Bulletin Number: T-16-04  
Model Years: 2015-2017

**VERSION: R01 (November 30, 2016)**

### 2015-2017 Slingshot Steering Shaft Pinch Bolt and Set Screw Replacement

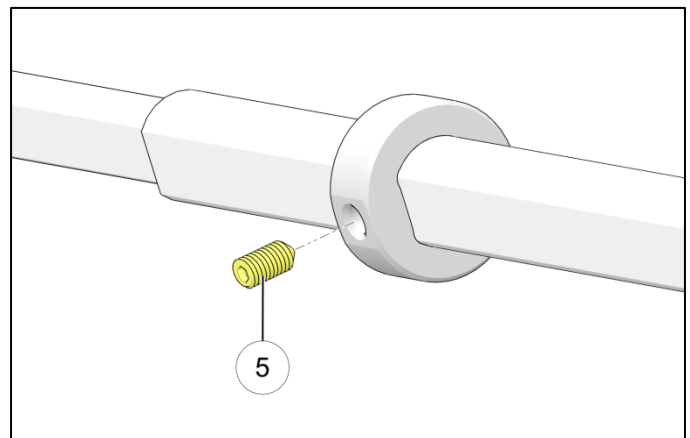
Make sure the NEW **Tapered Design** set screw is being installed.
